Independent Peer Review Panel

IPRP Report No. 10, December 4, 2015

Preliminary Comments on PG&E's May 2015 Update of the Three-Dimensional Velocity Model for the Diablo Canyon Power Plant Foundation Area and Site Amplification Using Analytical Approach

Figure 1. Comparison of measured V_s profiles from 1978 with profiles in the revised 3D V_s model within 30 m of borehole locations shown as Figure 4.1-2 in Fugro (2015a). As noted in Fugro (2015a), black dashed lines delineate depths where travel time uncertainties become large.

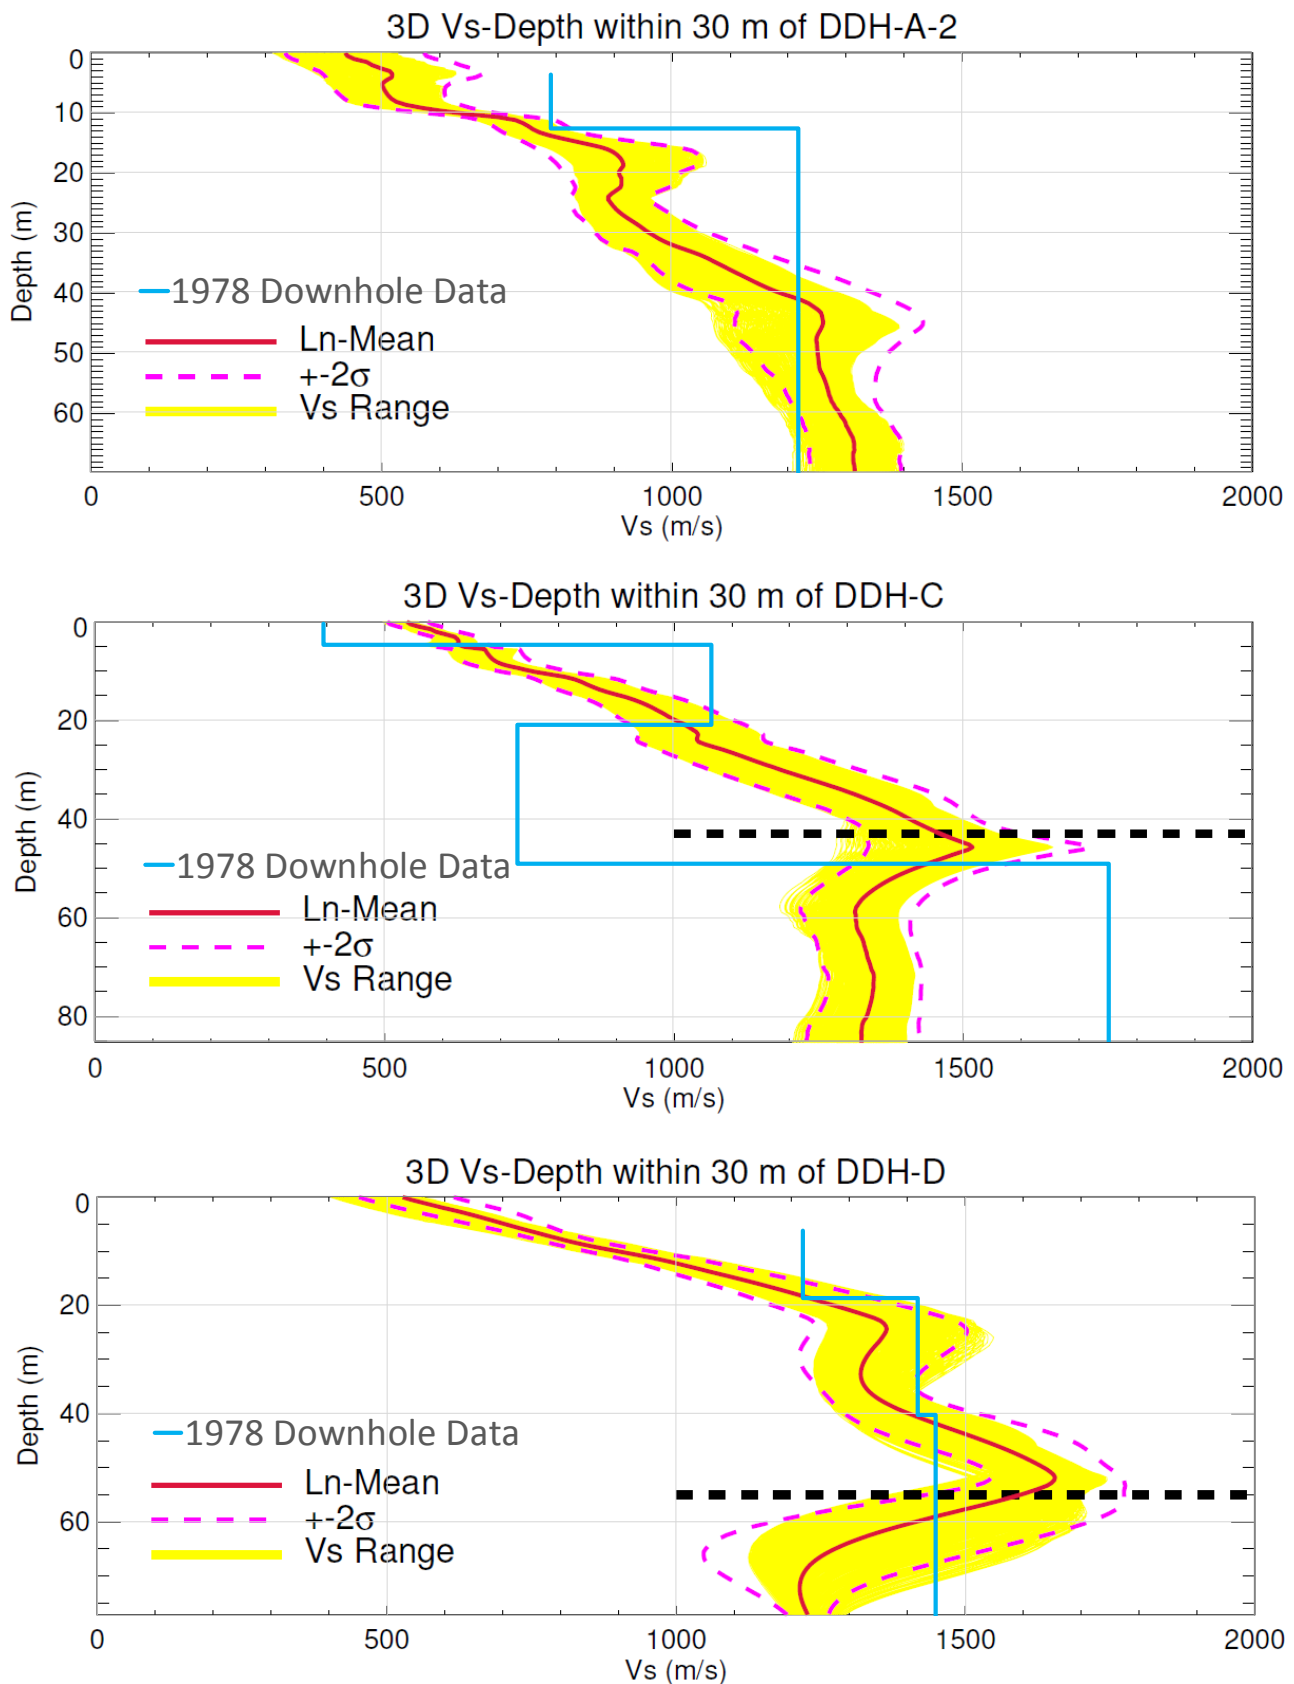
To facilitate direct comparison, we made Figure 1 by superimposing velocity profiles from the 1978 downhole measurements on velocity profile ranges (Figure 4.1-2 of Fugro, 2015a) derived from the 3D Vs model. We note that the comparison between Vs profiles obtained from downhole measurements and those obtained based on the revised 3D Vs model (Figure 1 in this report) is remarkably similar to the comparison shown in Figure 1 of the IPRP Report No. 9. In that figure, downhole velocity profiles are compared with the nearest profile from the 3D tomographic survey presented in the CCCSIP report. In IPRP Report No.9, we stated that Vs profiles from the tomographic model do not appear to reproduce the variation in Vs with depth in nearby measured profiles.

Figure 1 of this report shows similar results: the ranges of Vs profiles from the updated 3D Vs model do not reproduce the variation in Vs with depth from the downhole measurements. In other words, the updated 3D model does not provide better consistency with the 1978 downhole measurements. Measured Vs values in DDH-C are all outside the range of Vs values from the 3D Vs model. This observation also applies to large portions of the Vs profiles in DDH-A2 and DDH-D.

IPRP would like to see better agreement between velocity profiles from the updated 3D model and from 1978 downhole measurements or reasonable explanations for inconsistencies. However, we realize adjustments are still being made to the 3D model. If the fit to the 1978 downhole measurements does not improve in the final 3D Vs model, sufficient explanations should be provided.
